Service Bulletin

SB-ASTM-F2-02, Revision 02

Date of Initial Publication: 09-Sep-2024 Publication Date of this Revision: 26-Sep-2024

Exchange of Fuel selector valve SB-ASTM -F2-02

Pic. 3.12 Lower section panel

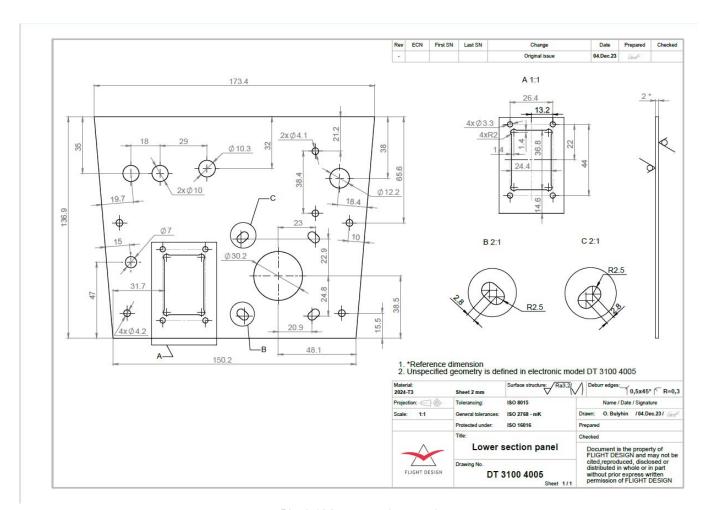
- 1.1 Produce slots in lower panel according to sketch (See pic.3.12) View B, C use tools from chapter 2.4.
- **Note:** In some older configurations of F2-LSA lower section panel is already fit with with the new design Fuel Selector Handle Cover (see table 1.) In this case, no step is needed.

Pic.3.13 Installation of Mounting plate with new design Fuel Selector Handle Cover

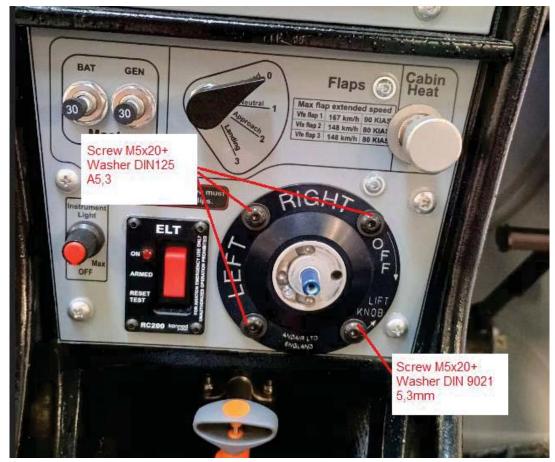
3.1 Install adjusted Mounting plate, new design Fuel Selector Handle Cover (See table 1 pos.10) to lower section panel (See Pic.3.13).

Note: Position of mounting plate should correcspond with Pic.3.13.

Pic. 3.17.1 Adjusting of Fuel bracket

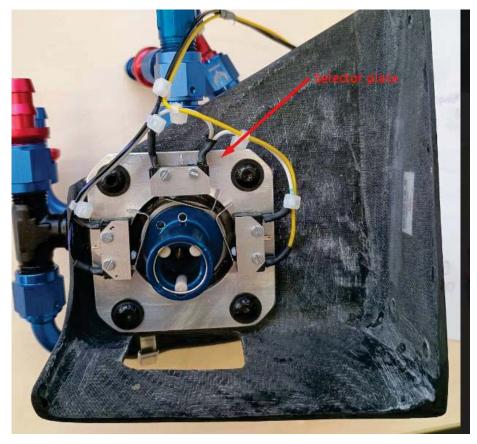
Drill 4pcs extra holes Ø5mm and adjust central hole (See pic.3.17.1)

Pic. 3.17.2 Installation on Fuel Bracket

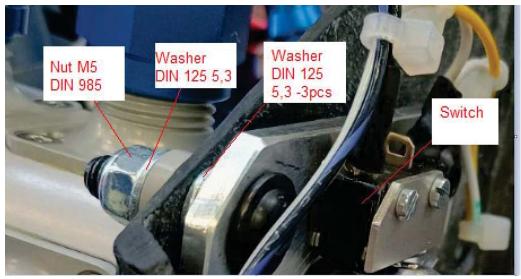
table 1. Pos.22) and nuts M5 DIN 985 (See table 1. Pos.22) with new Selector plate (See table 1. Pos.14) and switches (pos.46,49,11 Pic.3.16)

- Note: Location of fitting parts are displayed on Pic. 3.17.2.
- Note: Use Loctite 648 for mounting bolts without self locking nuts.
- Note: Distance between Selector plate and Fuel bracket should be 3mm (See pic.3.17.3).

Pic. 3.17.4 Adjusting Connection flange ECA1#2

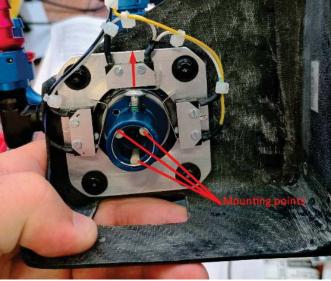
4.9.4.1 Drill hole Ø3,5mm in Connection flange ECA1#2

4.9.4.2 Cut the thread 8-32

4.9.4.3 Install screw AN526-832R8-1pcs (See table 1 pos.25)

- Note: Use dimesions dirrectly from pic.3.17.2. The screw must point upward in relation to the three mounting points.
- **Note:** The screw installation length should correcspond with pic. 3.17.4.
- Note: Use Bonding liquid middle strength (Green) (See chapter 2.3.3).

Pic. 3.17.5 Fixing the Adjusted Connection flange ECA1#2 with Fuel selector valve

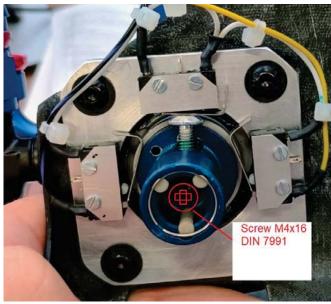
4.9.4.4 Fix the Adjusted Connection flange ECA1#2 with Fuel selector valve using Screw M4x16 (See table 1 pos.29) Pic 3.17.5.

Note: Use Loctite 648 for mounting Screw M4x16.

Pic.3.18. Installation of preassembled Fuel selector valve back to Tunnel

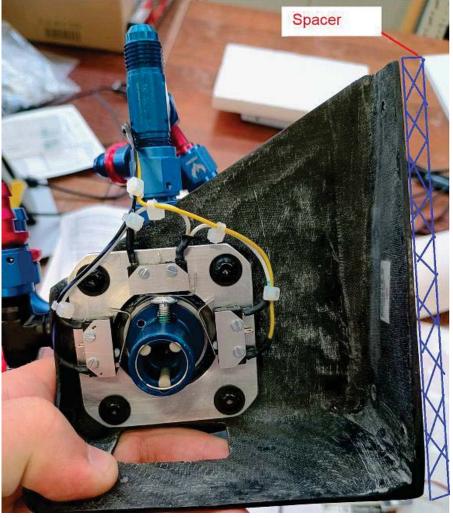
4.10 Install preassembled new Fuel selector valve back to Tunnel (See pic.3.18).

- 4.10.1 Screw the Screws ISO 7380 M5x35– 4pcs (See table 1 pos.23) with Nuts M5 and washers DIN 9021-5,3mm (See Pic.3.18).
- Note: Use Spacer for installation (See table 1 pos.11).

Pic.3.26 The initial arrangement of wires in the Faston connector

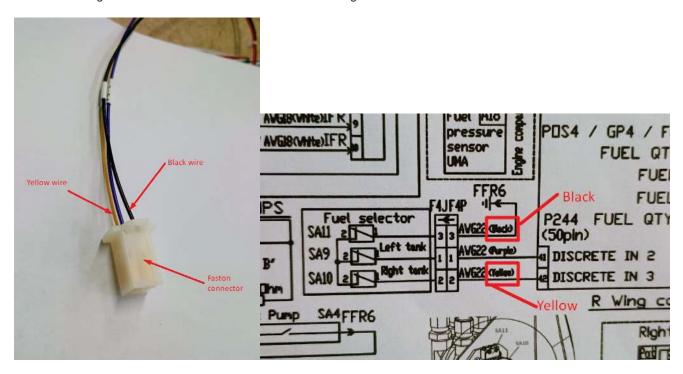
Step 6 Connector's pin-out correction

Change wires on Faston connector according new Fuel selector valve's positions.

Open the connector, Swap the Black and Yellow wires, assembly connector.

The initial arrangement of wires in the connector is shown on Fig.3.26.
